Model: Brz-MF1	Date: 23-May-16	No.: RD255002b
----------------	-----------------	----------------

Subject: Firmware Release Note: Engine		Prepared by: T. Tachibana	
From: 2nd Tech Service Sect., MFP/Printer Tech Service Dept.			
Classification:	<input type="checkbox"/> Troubleshooting <input type="checkbox"/> Mechanical <input type="checkbox"/> Paper path <input type="checkbox"/> Product Safety	<input type="checkbox"/> Part information <input type="checkbox"/> Electrical <input type="checkbox"/> Transmit/receive <input checked="" type="checkbox"/> Other (Firmware)	<input type="checkbox"/> Action required <input type="checkbox"/> Service manual revision <input type="checkbox"/> Retrofit information <input checked="" type="checkbox"/> Tier 2

Model: Brz-MF/P		Date: 29-Jun-16	No.: RD255023
Subject: FSM correction on replacing the fusing unit		Prepared by: H. Morishima	
From: 2nd Tech Service Sect., MFP/P Tech Service Dept.			
Classification:	<input type="checkbox"/> Troubleshooting <input type="checkbox"/> Mechanical <input type="checkbox"/> Paper path <input type="checkbox"/> Product Safety	<input type="checkbox"/> Part information <input type="checkbox"/> Electrical <input type="ch

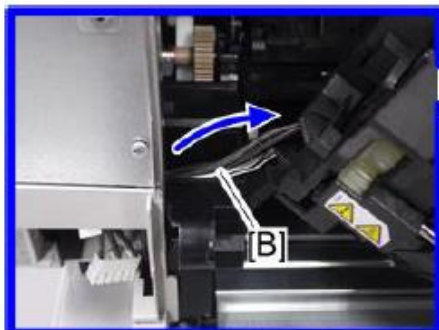
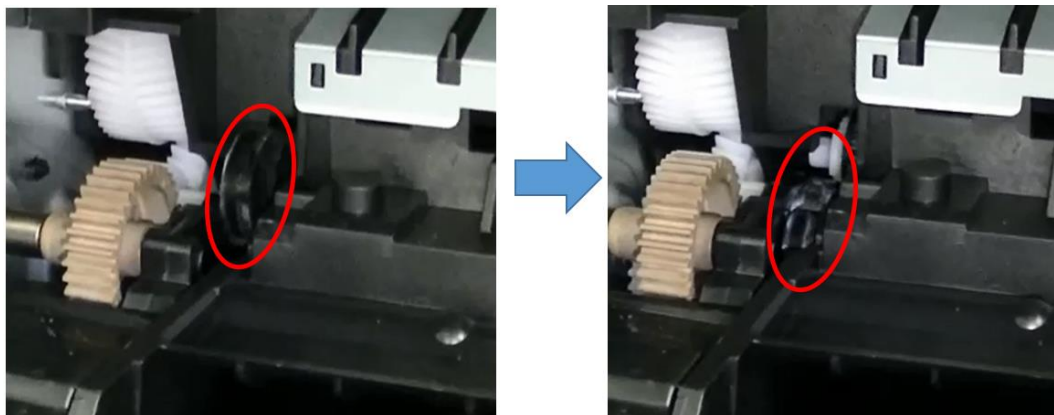
Please add the following descriptions **in bold** to your field service manual.

- When removing the fusing unit [A], release the harness [B] from the mainframe.

- When reinstalling the fusing unit, do the following steps.

(1) Turn ON the power switch after removing the fusing unit and opening the rear cover.

2.Operation Panel-2

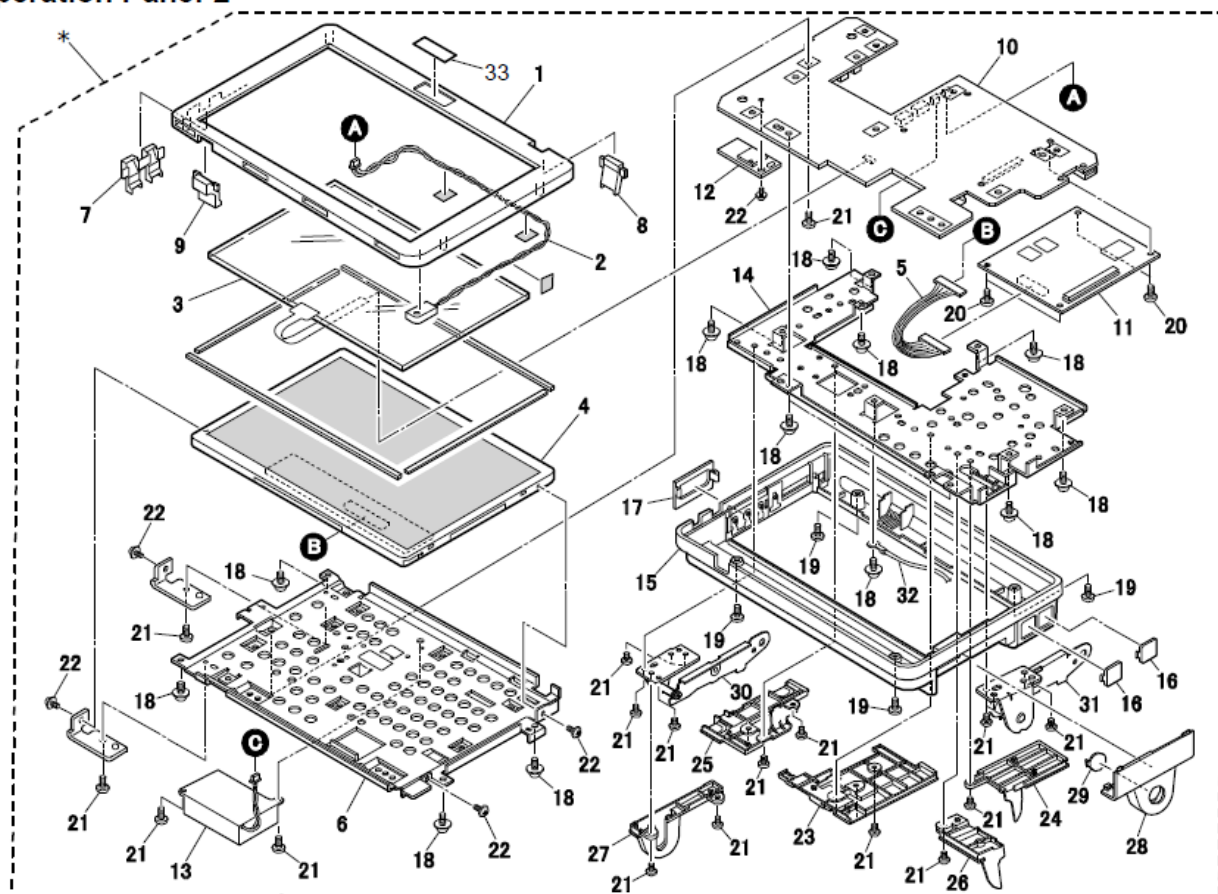
Change/Reason: *The part numbers announced in the original bulletin were incorrect. This bulletin has been re-issued to correct the mistakes.*

Correct part number	Description	Q'ty	Int	Page	Index	Note
<i>D2411522</i>	<i>PCB:SUB:ASS'Y</i>	1	-	4	10	
<i>D2411530</i>	<i>PCB:MAIN:ASS'Y (EU/NA/AA)</i>	1	-	4	11

4. Paper Feed Section

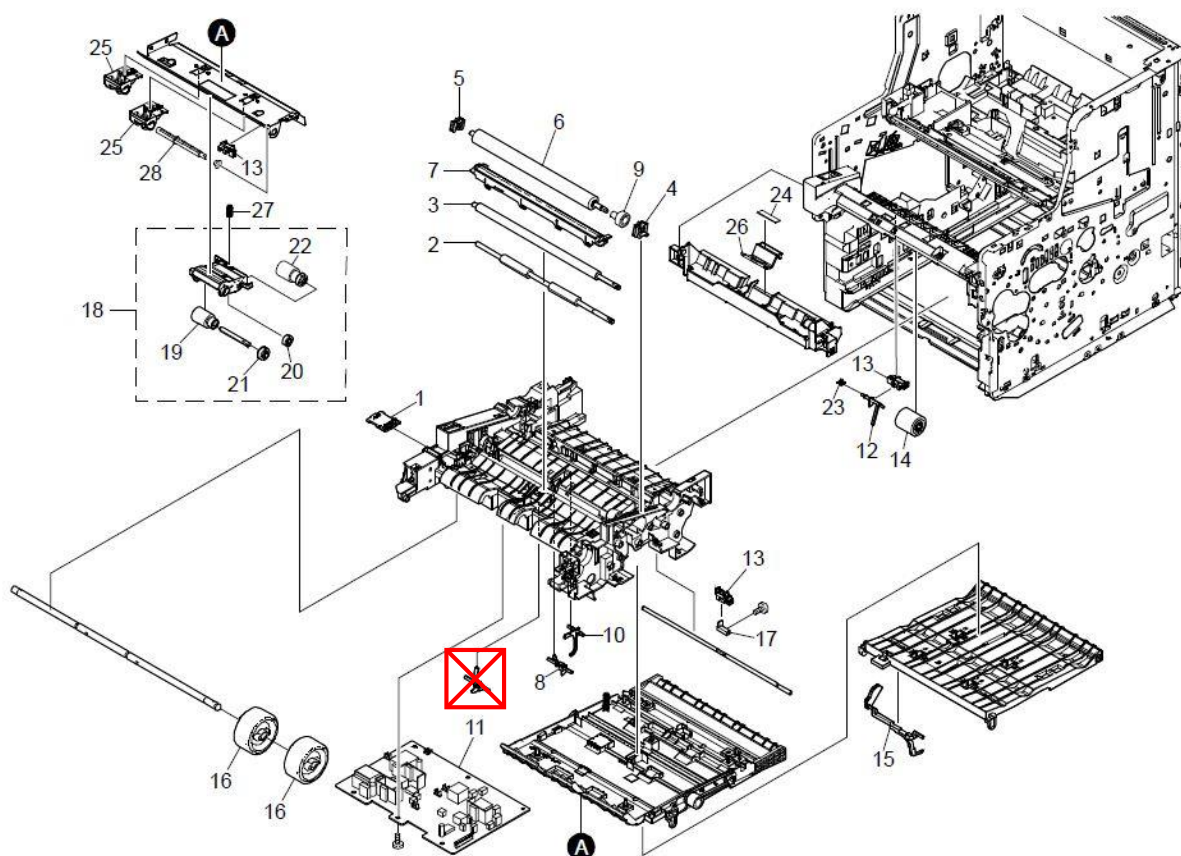
Change: The illustration of the actuator outlined in red was deleted.

Reason: Brz-MF1 does not have this actuator.

10. Drive Section

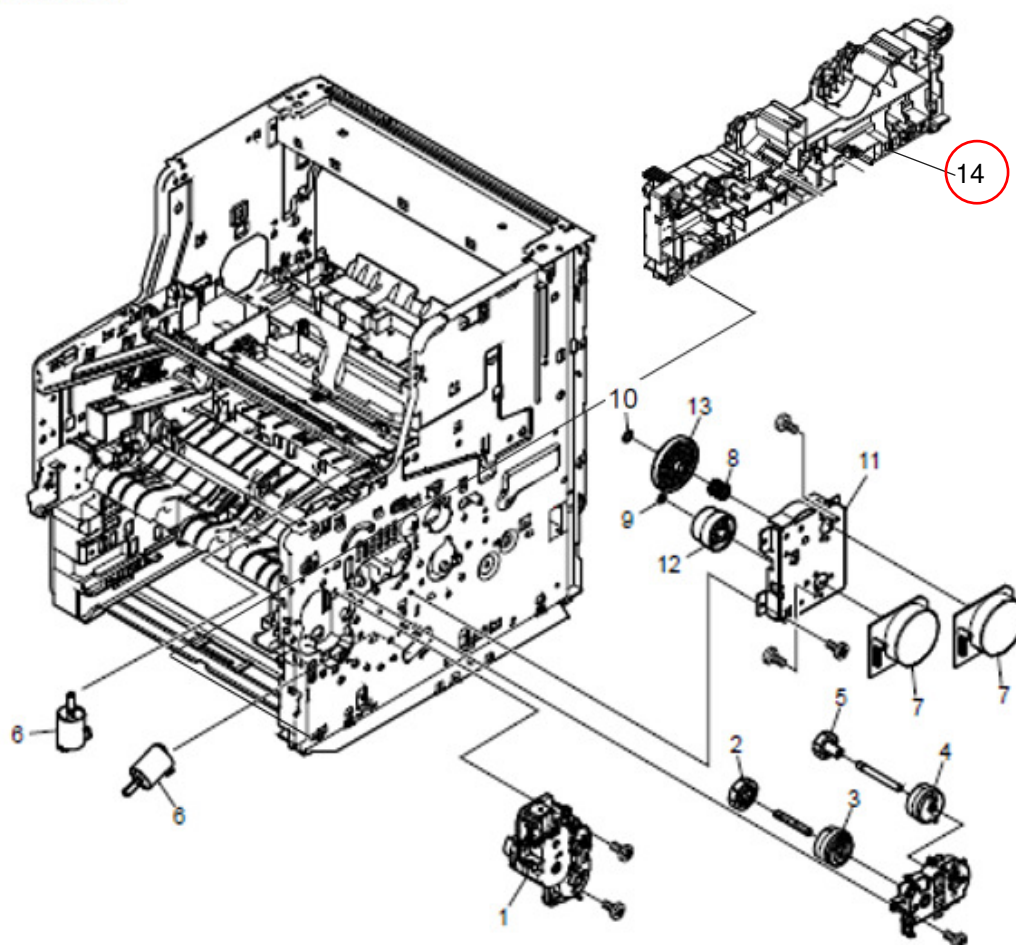
Change: The guide cassette has been registered as a service part.

Old part number	New part number	Description	Q'ty	Int	Page	Index	Note
	M2811182	GUIDE CASSETTE R	0-1	-	22	14

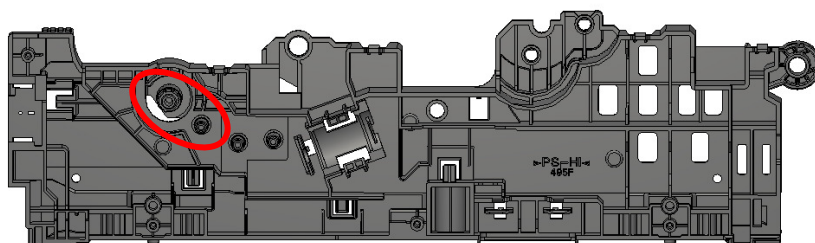
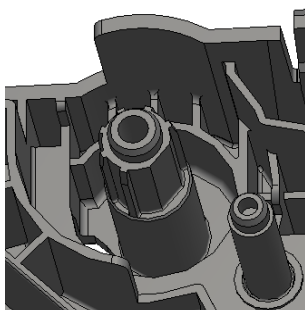
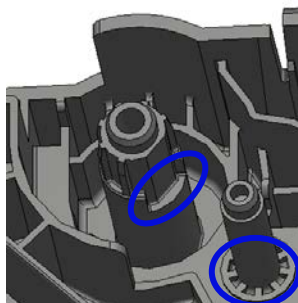
The shafts circled in red have been modified because they may turn white or break. If the shafts are broken, SC501-01(Paper Feed Tray Lift Motor Error (Tray 1)) appears.

New: The shape of the parts circled in blue have been modified.

6. Troubleshooting > Jam Detection > Sensor Layout (P.580~)

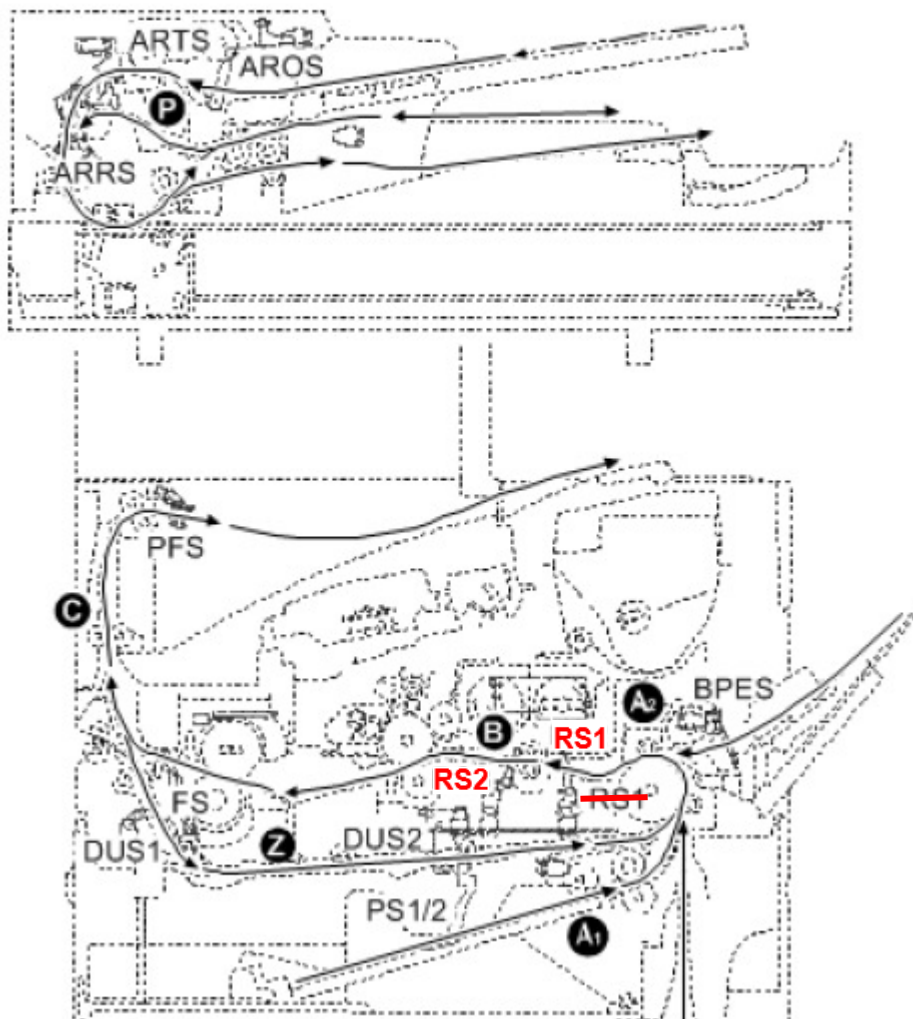
Please correct the descriptions **in red** to your field service manual.

8. Exit Section

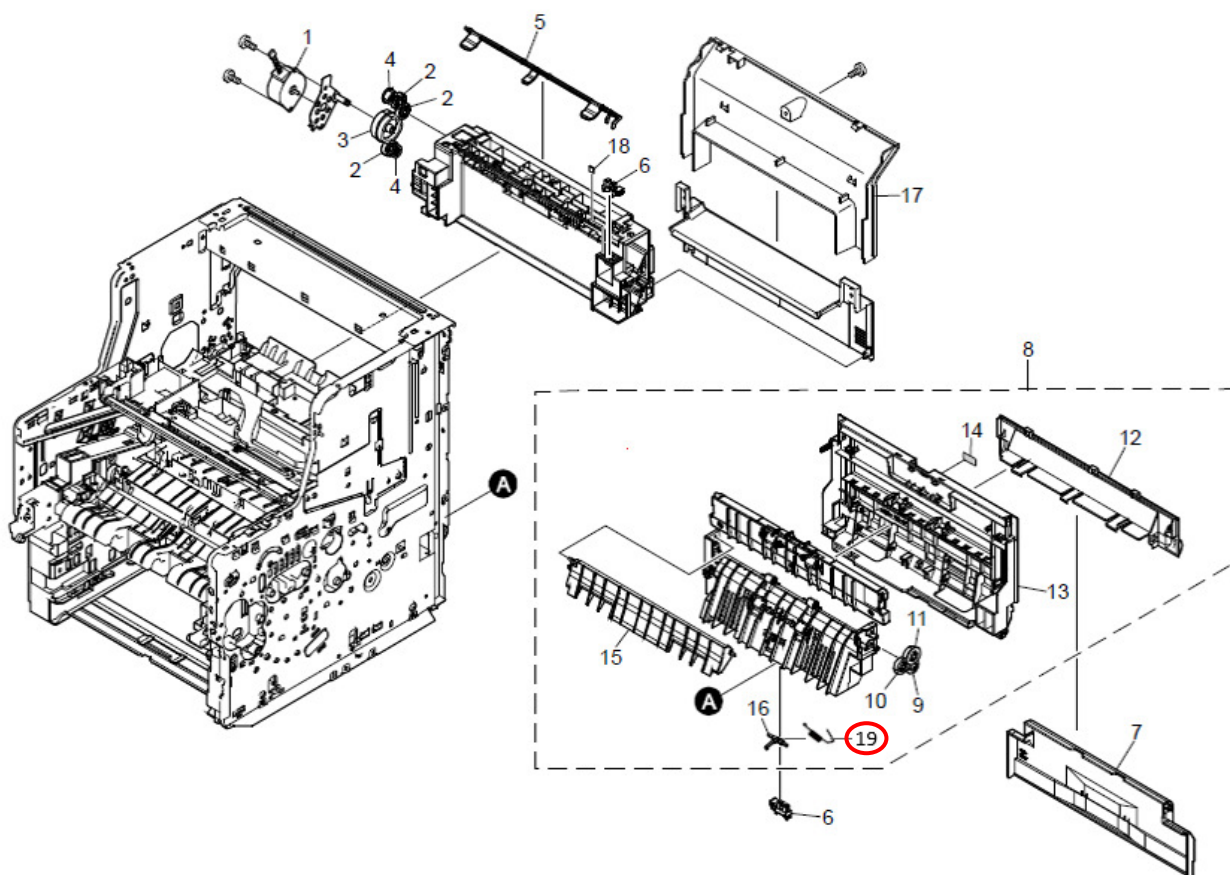
Change: A new part has been added.

Reason: To make it possible to replace the spring individually when a duplex jam occurs (Jam code: 86).

Part number	Description	Q'ty	Int	Page	Index	Note
M2814458	SPRING ACTUATOR DU	1		18	19
